ADDENDUM #1

Reference: Weber State University
Women's Softball Field Venue

DFCM Project #: 08240810

**Addendum No. One
for the
WSU Women Softball Venue
MHTN Project No. 2008547.00**

AS103
CONSTRUCTION DOCUMENTS
03 FEBRUARY 2009

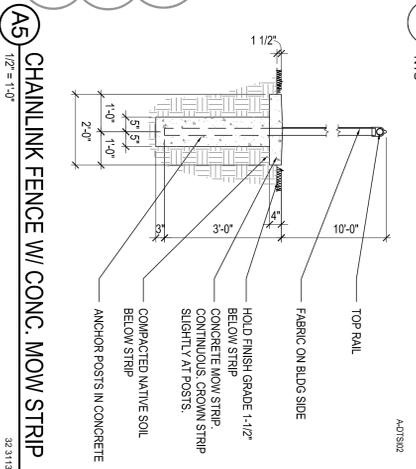
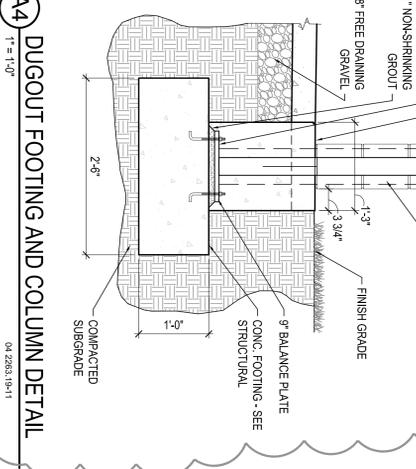
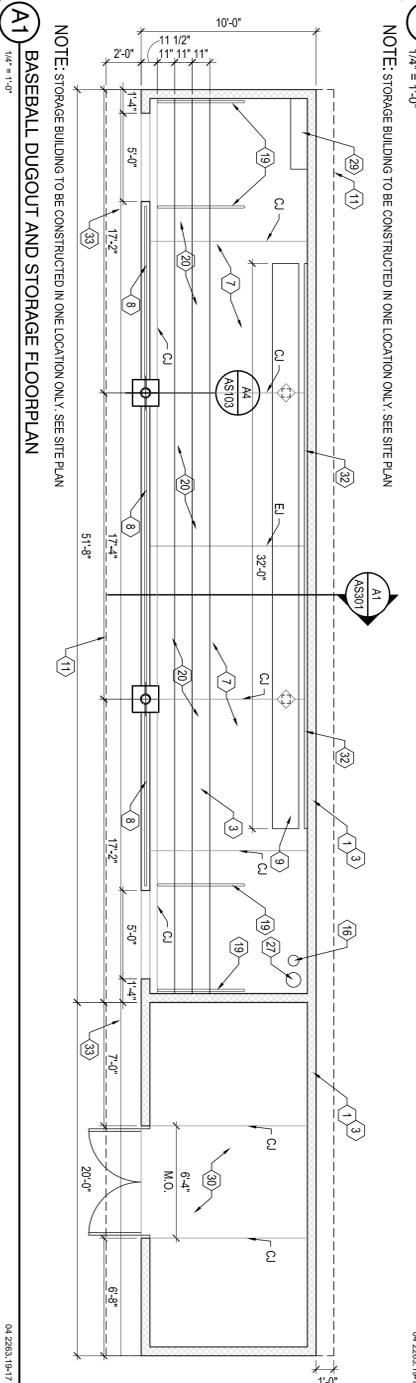
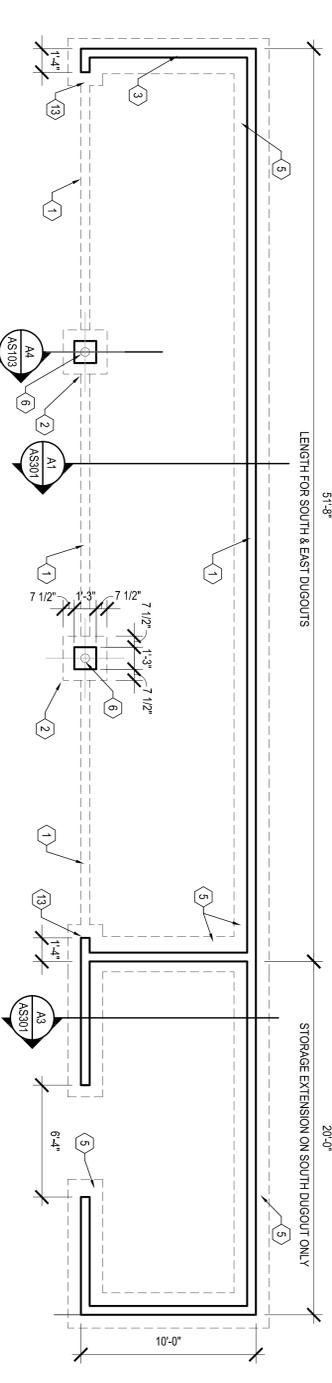
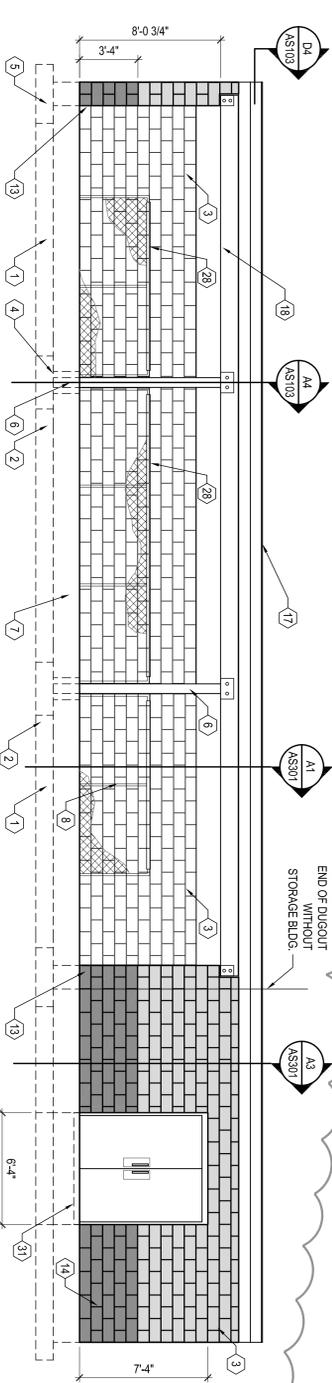
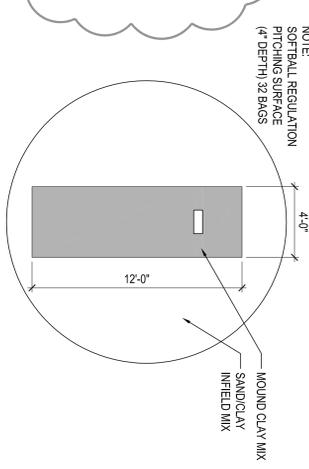
A1.5 SHEET AS103

- A. Detail A1: Baseball dugout and storage room plan** are revised as follows:
1. Delete the 2" dimension between the dugout and the storage building
 2. Revise the overall dimension of the dugout from 51'-6" to 51'-8"

3. Add control joints as shown in the storage building slab.
 4. Revise the width of the stair dimensions to 11"
 5. Add the note "end of dugout without storage building".

- B. Detail B1: Baseball dugout and storage footing and foundation plan** are revised as follows :
1. Added the text "storage extension south dugout only"

2. Added the text "length for south and east dugouts".
- C. Detail: C1: Baseball dugout and storage elevation** are revised as follows:
1. Add the note "end of dugout without storage building".

2. Add the note "south only, east similar, no storage room extension"
- D. Detail D2 AS103** Delete the cheek wall as per revised Detail shown.
- E. Detail D4 AS103:** Revise edge detail as shown.

A3 STORAGE BUILDING SECTION
1" = 1'-0"

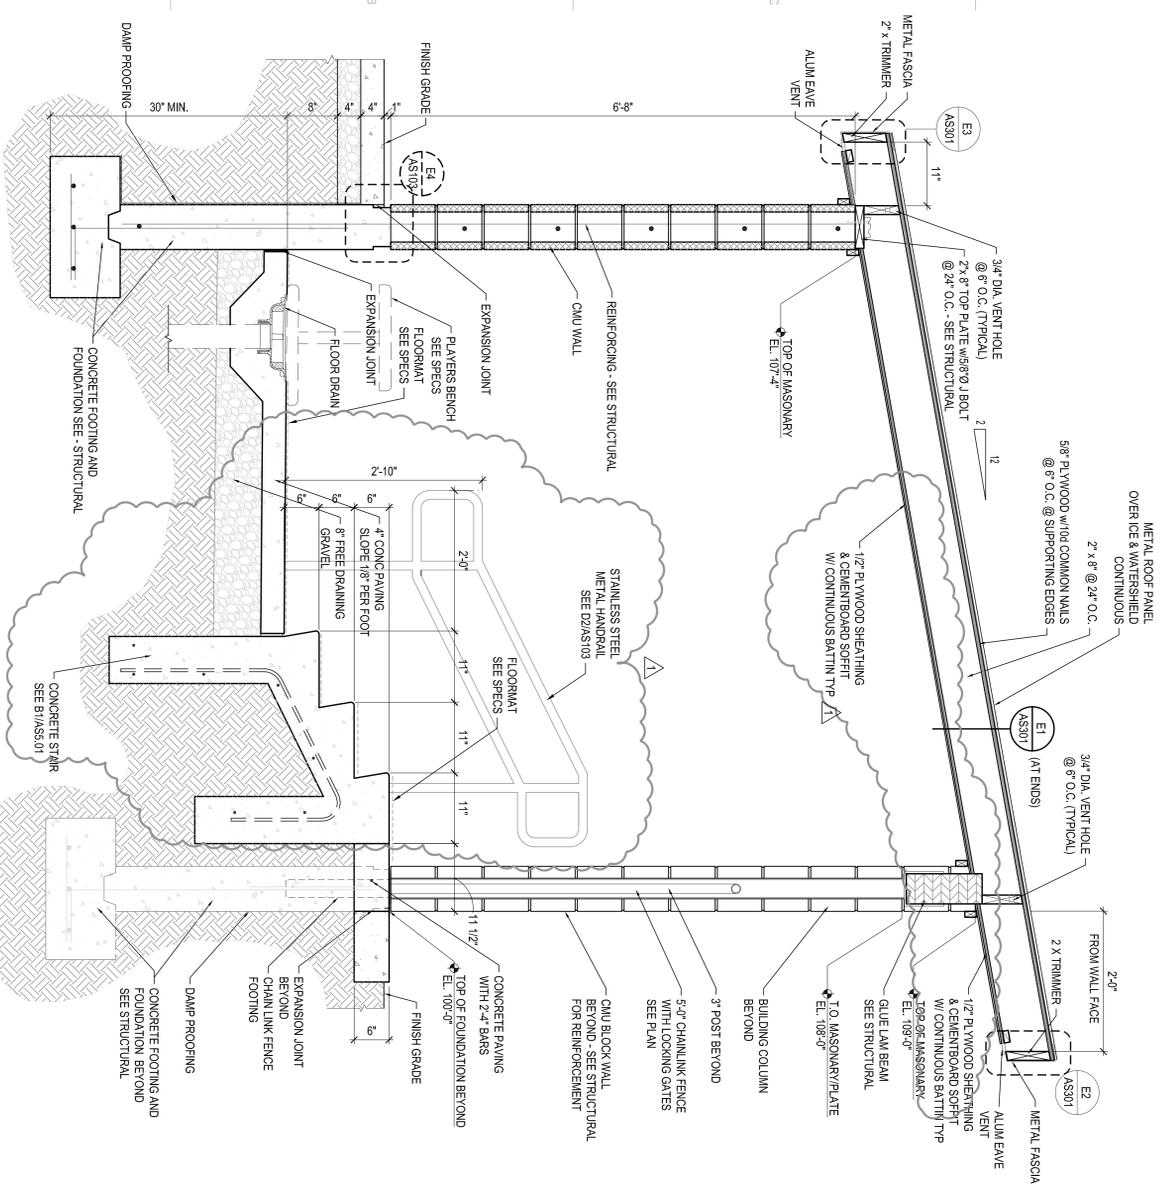
- A. Detail A1** Section revise text "1/2" plywood sheathing and cement board soffit" to read "1/2" plywood sheathing and cement board soffit with 1"x 2" batten at all joints continuous "
- B. Section A3**
1. Revise text "1/2" plywood sheathing and cement board soffit" to read " 1/2" plywood sheathing and cement board soffit with 1"x 2" batten at all joints continuous "
 2. Add the note "1"x 2" trim typical"
